Flavor Select (FS) Splash Plate Decal Update

Technical Bulletin Reference No. 2108-001

ICDI Drain Fitting Update

Technical Bulletin Reference No. 2108-002

- Instruction decal Obsolete PN 06-3194
- Instruction decal New PN 06-3194/01

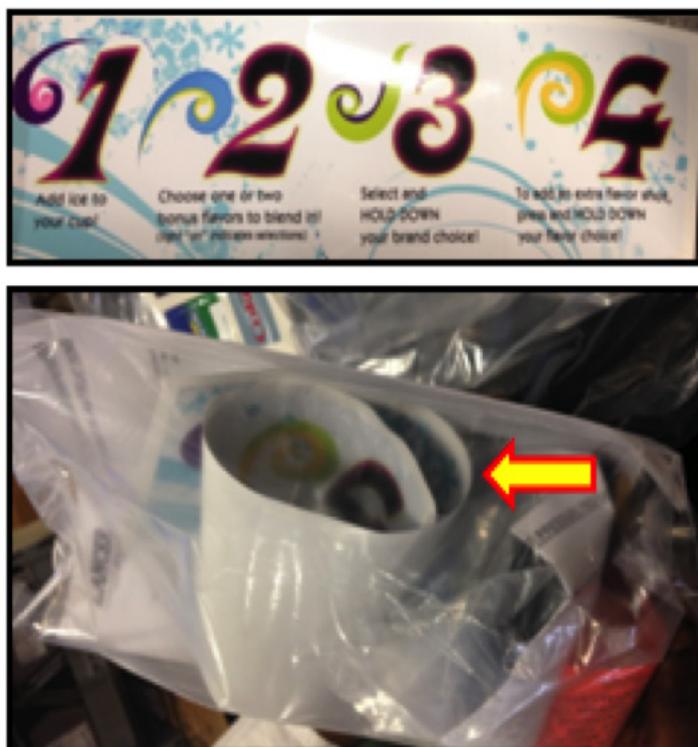
Beginning September 2014, PN 06-3194, the FS splash plate instruction decal will be obsolete and replaced with PN 06-3194/01. The obsolete instruction decal does not address the FS's new blend/dose capabilities, (refer to Technical Bulletin: **2102-002**). The FS's new dosing capability is an optional feature that the retailer can choose whether or not to utilize. The new instruction decal will not ship installed on the unit so that the operator can choose whether or not to include the dosing portion of the instruction decal on the unit. The updated decal will ship along with the unit in the installation kit, to be applied during installation and accommodate the operator's decision to just use the blend function of the Flavor Select or both the blend and dose functions of the unit.

BEFORE CHANGE

Pictured: Obsolete decal installed on the production line

AFTER CHANGE

Pictured: New decal delivered uninstalled in the included installation kit
